Response to Submissions

New Berrima Clay/Shale Quarry

Modification 2

Project Approval No. 08_0212

Figure A
 BRIDGE REPLACEMENT:
 ENGINEERING DESIGNS

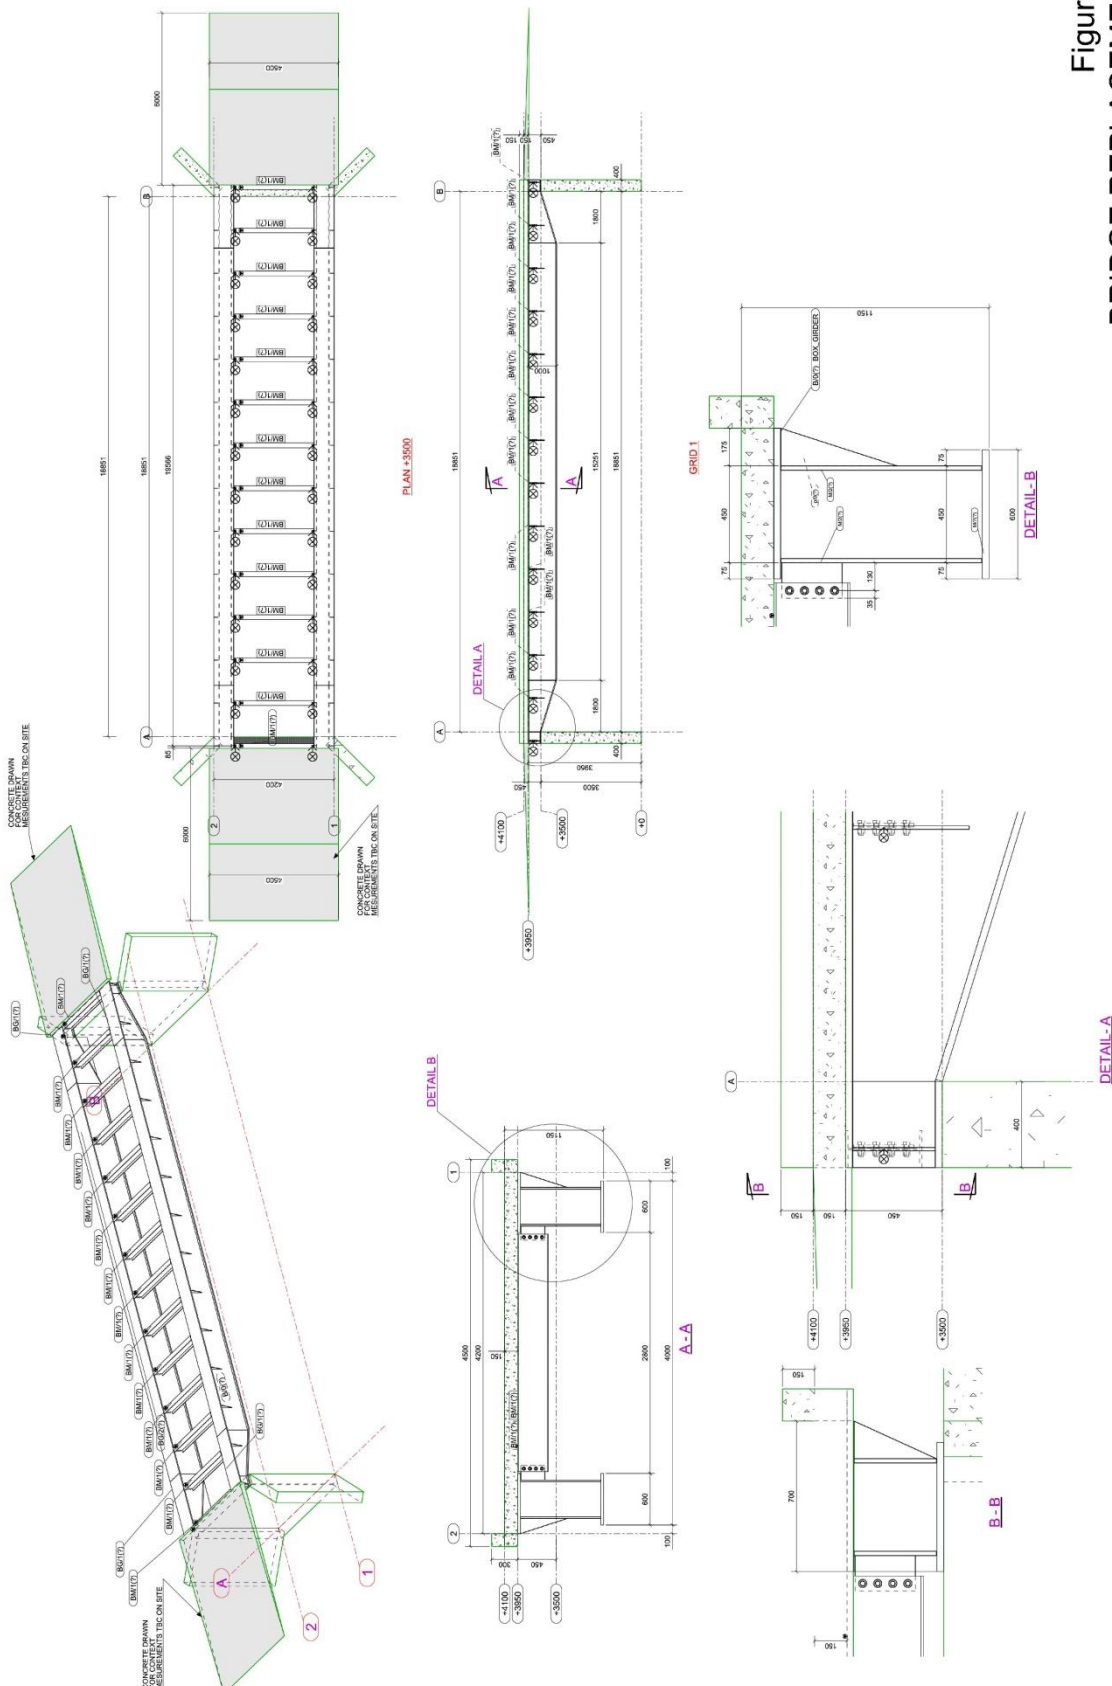
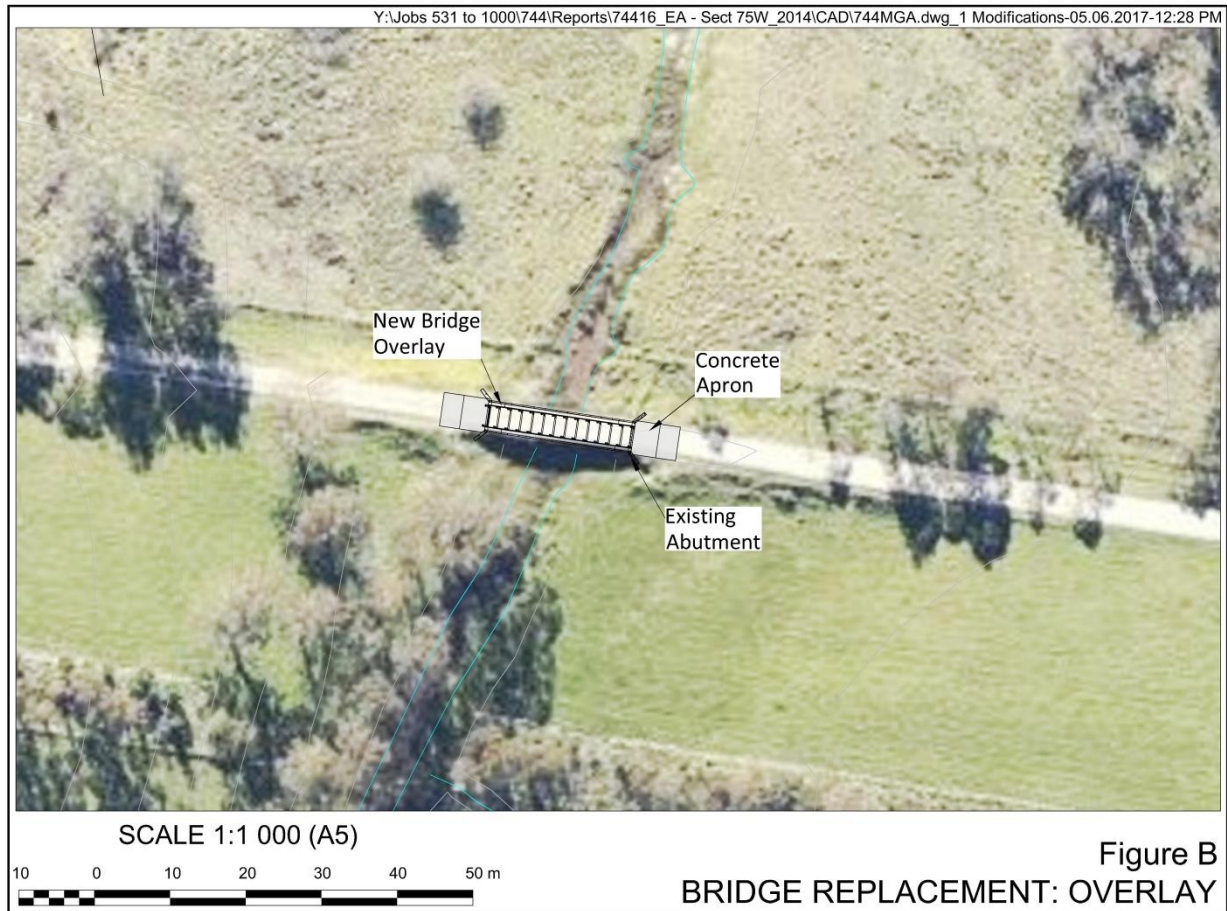
Any approval for the modification should include a Condition of Consent requiring the proponent to consult with DPI Fisheries (ahp.central@dpi.nsw.gov.au) on the detailed design of the proposed watercourse crossing.

Given the proposed amended modification to replace the bridge utilising the existing abutments would result in no disturbance to the channel bed or banks, no further consultation with DPI Water is considered necessary. Notwithstanding this, detailed engineering drawings of the bridge are provided in **Figure A**.

Figure 1: Location of AHIMS site 52-4-0175

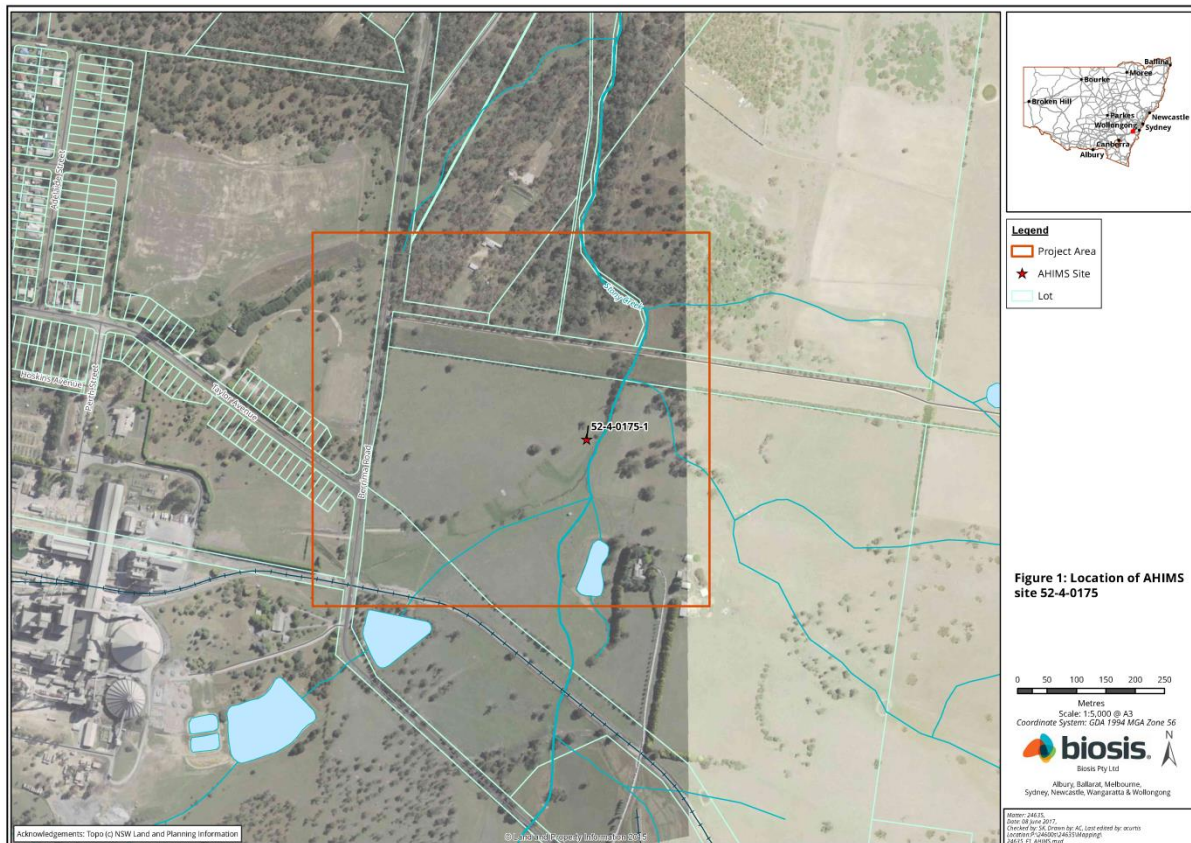
An archaeologist should survey the proposed new causeway at Stoney [sic] Creek. This is because of the archaeological potential associated with site 52-4-0175 and the proposal to build a new crossing over Stoney [sic] Creek on land that has been subject to much lower levels of disturbance than the existing access track.

The causeway and associated access track are located within a gradual slope and small terrace associated with Stony Creek (see Figure 1). Visibility was poor (>5%) with no exposure present except for areas of exposure at the causeway location which appears to have shallow soil horizons with areas of exposed bedrock present. Based upon the surface characteristics the site 52-4-0175 appears to be confined to the crest and is likely to have been previously disturbed in the immediate vicinity of Rocky Creek (and therefore the causeway) due to the shallow soil horizons and levels of inundation that this area is likely to have experienced.

The site card states that the site extent for 52-4-0175 has been determined through applying a generic buffer to the site features with the site boundary extending across the access track and Rocky Creek by a substantial distance. The site card also indicates that an extensive series of grinding grooves are present at seven locations with a concentration of artefacts located in areas of disturbance. The site card further concludes that 52-4-0175 may have an extensive PAD associated with it in the shallow soils overlaying the bedrock. Total Earth Care (2003) has assessed site 52-4-0175 as possessing a high degree of scientific significance. Based upon a review of the site card, the characteristics of site 52-4-0175 and prevalence of sites along Stony Creek, the possibility of Aboriginal objects being present cannot be discounted.
